Response to Comments

**RB Inyokern Solar Project
by R&L Capital, Inc. (PP16109)**

**Conditional Use Permit 23, Map #47;
Conditional Use Permit 27, Map #47; and
Inyokern Specific Plan Amendment 4, Map #47**

**RE: Response to Comments for Draft Environmental Impact Report – RB Inyokern Solar Project
by R&L Capital, Inc. (SCH #2017071020)**

Figure 3-10: PHASE 1 SITE PLAN

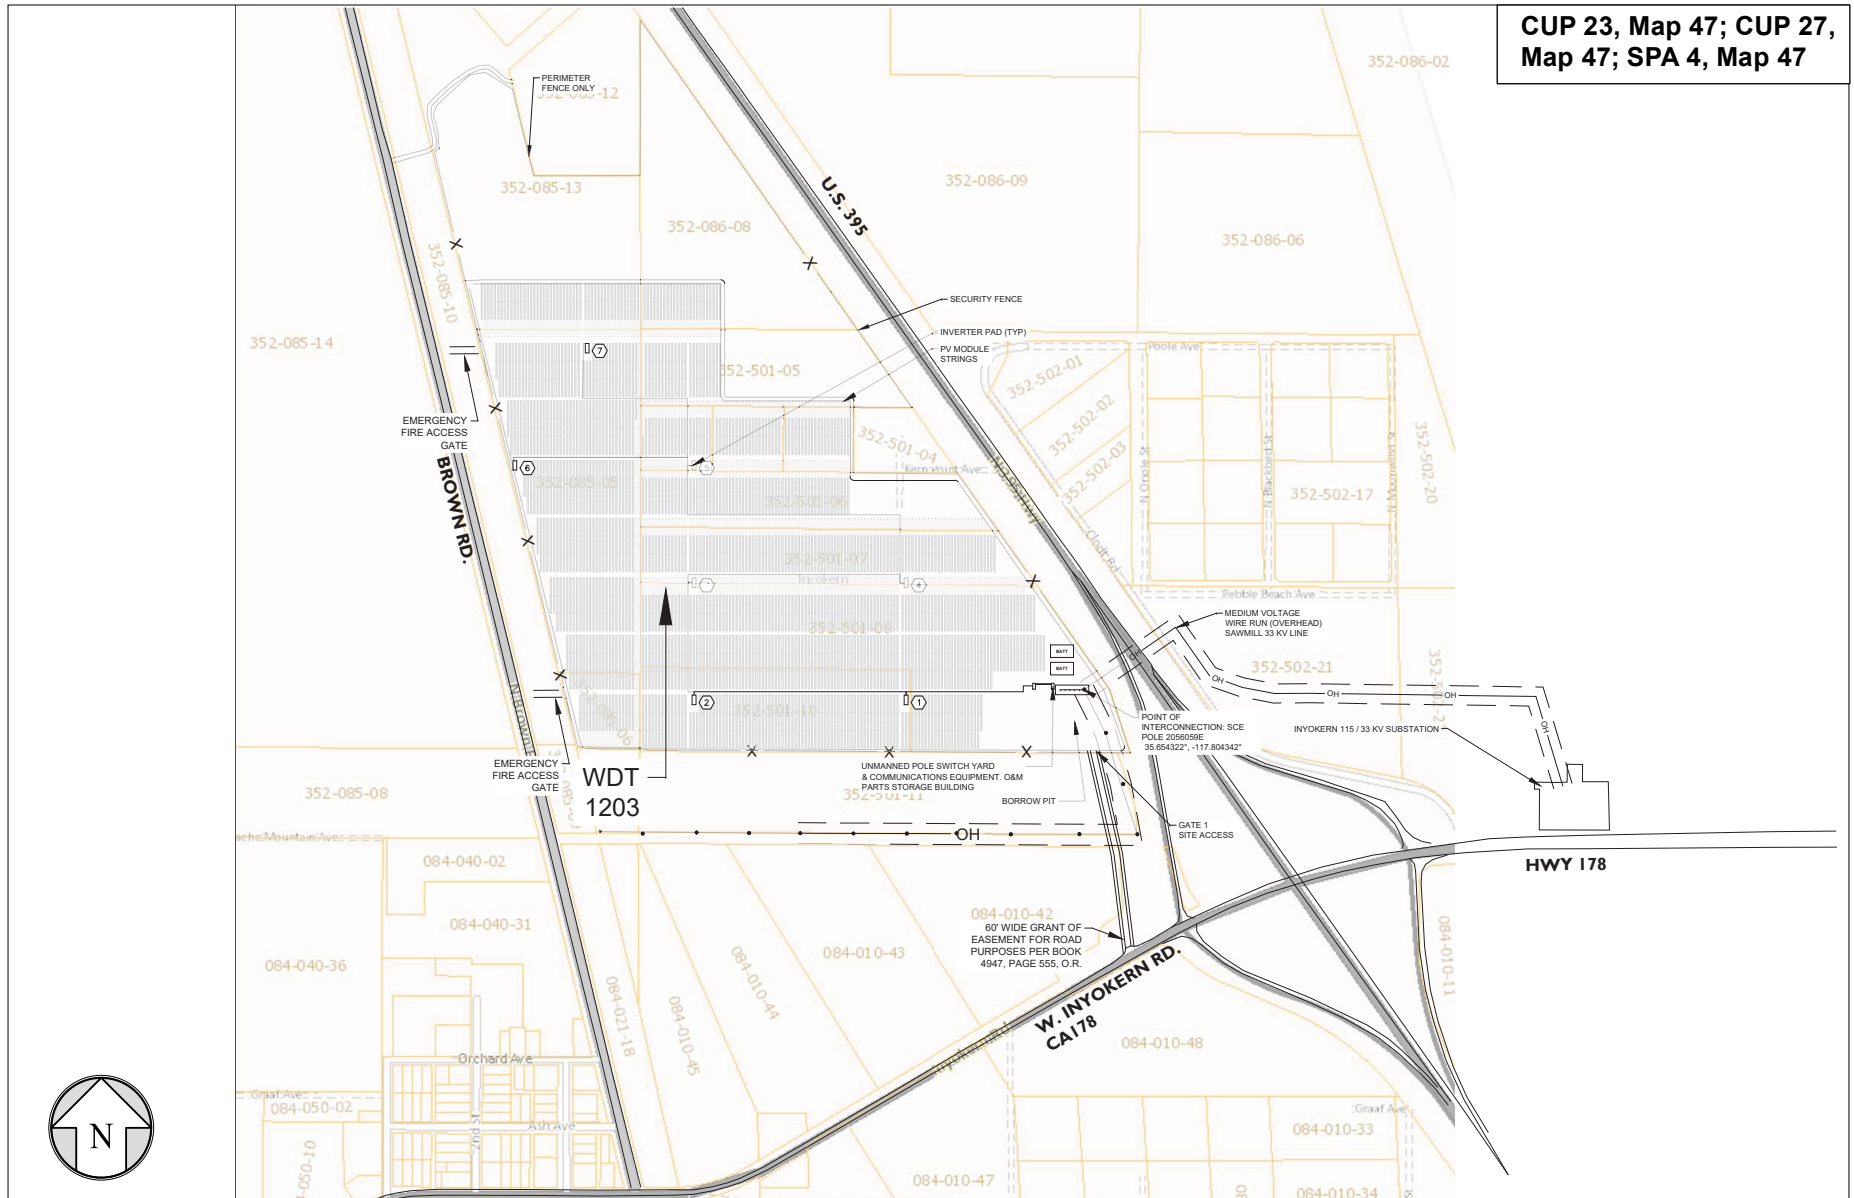
Figure 3.10, *Phase 1 Site Plan*, and **Figure 3.11**, *Phase 2 Site Plan*, have been revised as follows, to depict the updated configuration and characteristics of the proposed project.
